CRANDALL
CANYON MINE
ROOF CONTROL
PLAN REVIEW

CRANDALL CANYON MINE ROOF CONTROL PLAN REVIEW

US HOUSE COMMITTEE ON EDUCATION AND LABOR

May 6, 2008

Figure T.7 Strain SF Main West - North Barrier and South Barrier (LaM2D)

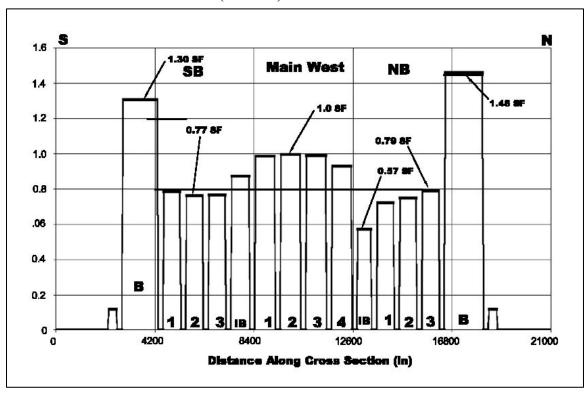
The review of the remaining barrier pillars compared to NIOSH guidelines showed planned mining in both the North and South Barrier produced barrier pillars with strain safety factor below the 2.0 minimum recommended in the NIOSH guidelines for Analysis of Retreat Mining Pillar Stability (ARMPS) safety factor for bounce prone mines. The low barrier pillar safety factors in this case should require further investigation.

Figure T.8 Five Step Damage Sequence – Vertical Stress (LaModel)

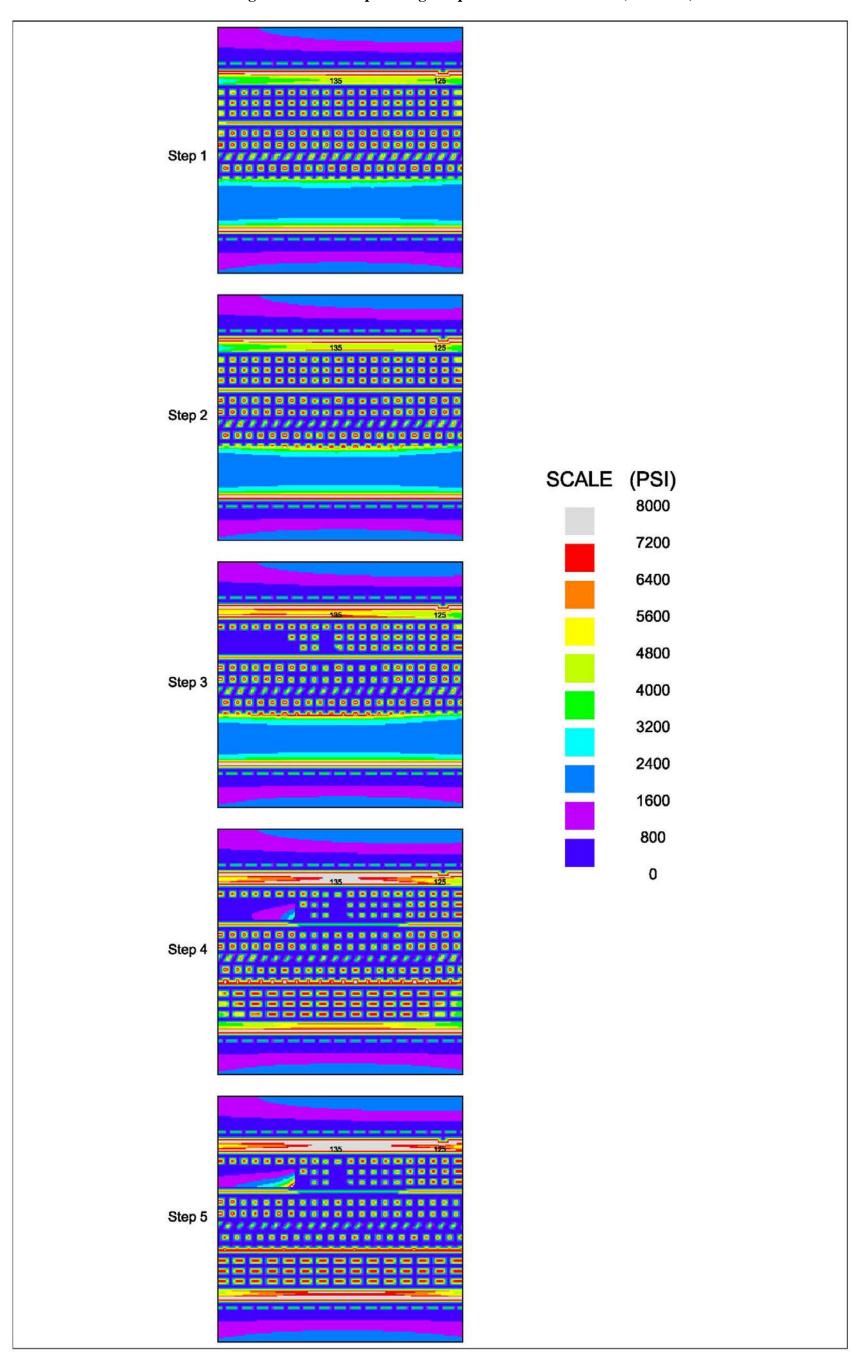
The following opinions have been formed after the review of the five step damage case modeling results as shown in Figure T.8 and Figure T.9.

- Step 3 The modeling results of this sequence with the assumed damage/deterioration of the Main West pillars indicated vertical stresses transferring to the South Barrier section pillars decreasing the pillar strain safety factor in an area coinciding with the August bounce. The reduction in pillar strain SF indicated potential questions on the pillar design in this area.

Figure T.10 Element Size Comparison - Pillar Strain SF (LaModel)

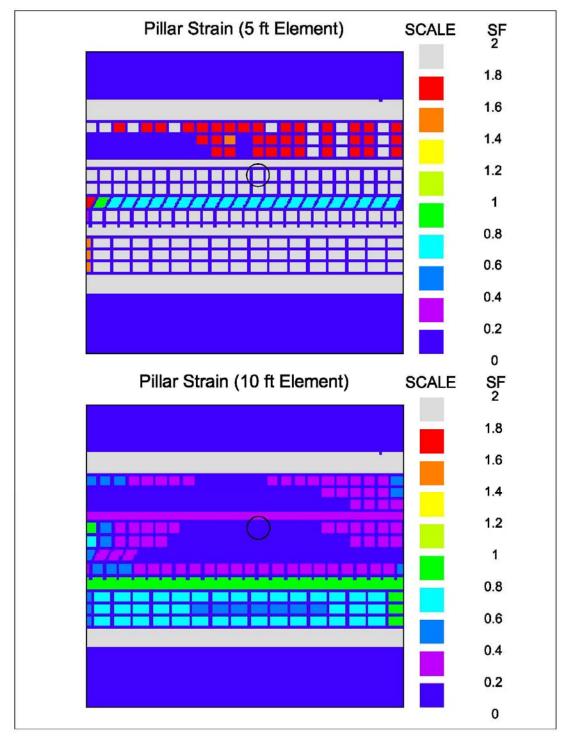
Two very commonly used element sizes (5 ft and 10 ft) were selected to evaluate the consistency of modeling results in both modeling programs. The smaller size provides more detail, while the larger size is used to evaluate larger areas. This model comparison yielded conflicting results. Norwest used ARMPS safety factors to compare the success or failure of this model. Norwest found results for the five-foot element within the LaModel produced higher pillar strain SF results for the same pillar shown in Figure T.10 while the LaM2D produced similar to identical results.

Element size variation may not always produce reliable results. A verification step on a simple area should be conducted to determine whether the results of an element size change produces consistent results and does not affect the conclusions drawn from the model results.

Figure 3.1-2 Convergence Main West and North Barrier (LaM2D)

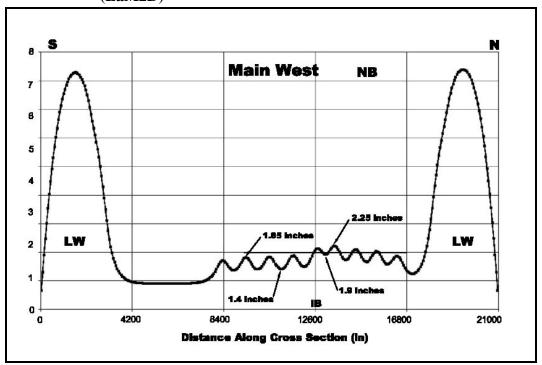
Figure 3.1-2 shows the addition of the North Barrier development. Note the convergence increase of the displacement just right of the 12600 line. This is the isolation barrier pillar between the Main West and the North Barrier development. Convergence is approximately 1.9 inches over this isolation barrier. The isolation barrier is not sufficiently sized due to a 0.5 inch increase in convergence. The convergence of the North Barrier pillars decreases as the pillars get closer to the 16800 line.

Figure 3.1-3 Convergence Main West, North Barrier and South Barrier (LaM2D)

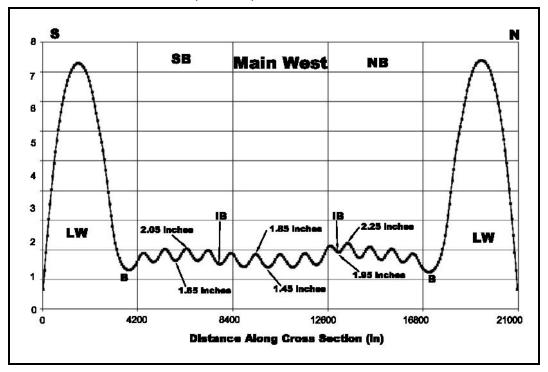
Figure 3.1-3 shows the addition of the South Barrier development. The convergence over the isolation barrier (left of 8400 line) between the Main West and the South Barrier shows very little increase in convergence above the 1.45 inches in the Main West. The convergence comparison identifies the width of the isolation barrier between the Main West and the North Barrier development to be questionable.

Figure 3.1-5 Vertical Stress Main West and North Barrier (LaM2D)

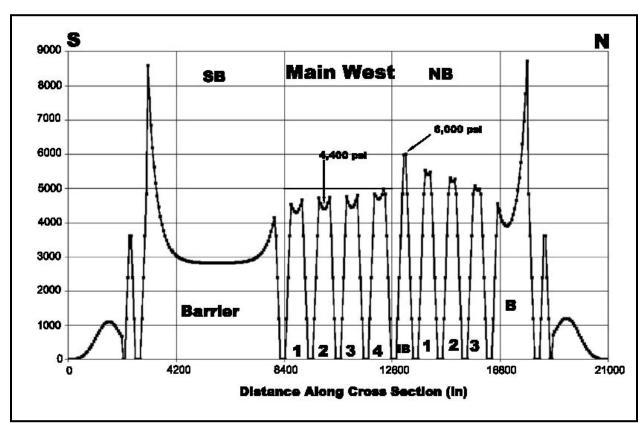
Figure 3.1-5 shows the effect of the North Barrier development on the vertical stresses. The stress level reaches 6,000 psi on the narrow core of the isolation barrier. The isolation barrier is not sufficiently sized for the depth of cover and to adequately balance the vertical stress load across the multiple developments of the Main West and the North Barrier. Stress levels have not reached the level of 10,000 psi over the North Barrier development. The barrier pillar (right of the 16800 line) shows the increase of vertical stress in the center to 3,900 psi. This vertical stress increase is due to side abutment stress from the adjacent longwall gob.

Figure 3.1-8 Strain SF Main West and North Barrier (LaM2D)

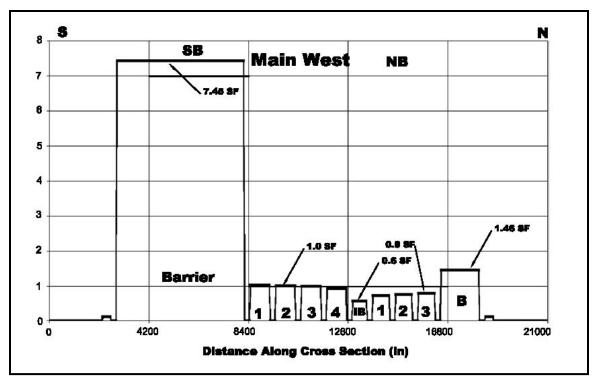
Figure 3.1-8 shows the development of the North Barrier. This mining of the northern barrier reduced the supporting width from approximately 450 ft to 135 ft, dropping the barrier SF from 7.35 to 1.46. The narrow isolation barrier between the Main West and the North Barrier possess the lowest SF in this design and results in the North Barrier pillar sharing more of the vertical stresses. Norwest identified a larger impact on the pillar strain SF adjacent to the isolation barrier than the pillars adjacent to the remaining north barrier pillar. The narrow isolation barrier required the adjacent pillars to carry more load than the potential load from side abutment across the remaining north barrier pillar. This indicates questions in the design of the isolation barrier pillar.
